SERVICE BULLETIN No. 002MP-32-001

LANDING GEAR – NOSE GEAR – MAINTAINABILITY PANEL

INTRODUCTION OF SELF-LOCKING NUT ATTACHING PARTS FOR TOGGLE LATCH AND TOGGLE LATCH STRIKE (AMENDMENT B)

FIGURE 1 - Amendment Label – Location

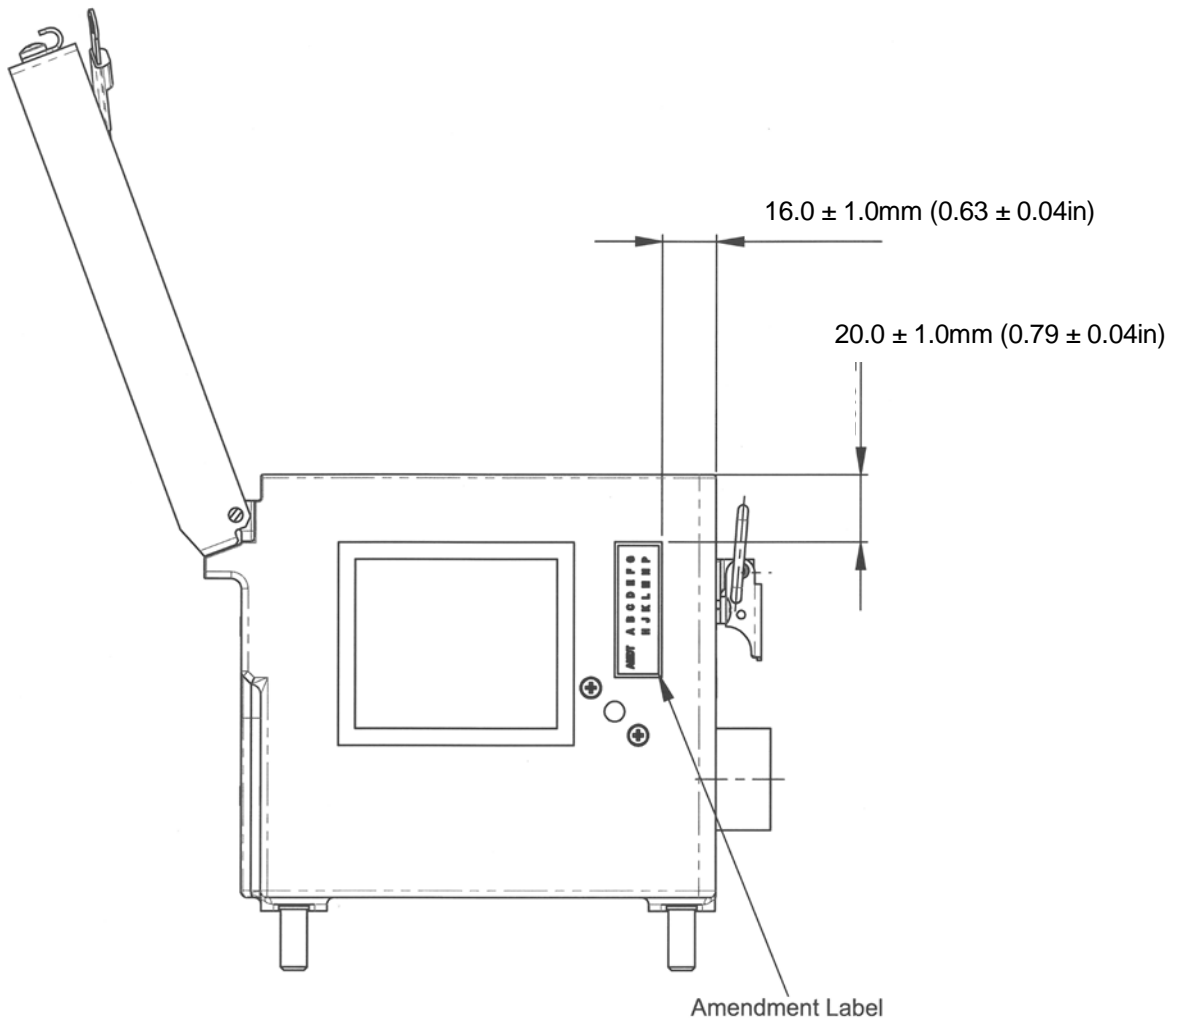
- (1) If the Maintainability Panel is fitted with an Amendment Label go to Para. 3.D.6.
- (2) If the fitment of an Amendment Label is required, carry out the following instructions.
- (3) Refer to Figure 1 and locally clean the area with IPA and allow to dry. Make sure the area is clean and free of grease.
- (4) Remove protective backing from the new Amendment Label and place in position as shown in Figure 1.
- (5) Apply even pressure across the Amendment Label to make sure the Label is secure.

- (6) Strike through Label "B" to indelibly identify the Maintainability Panel as Amendment B.
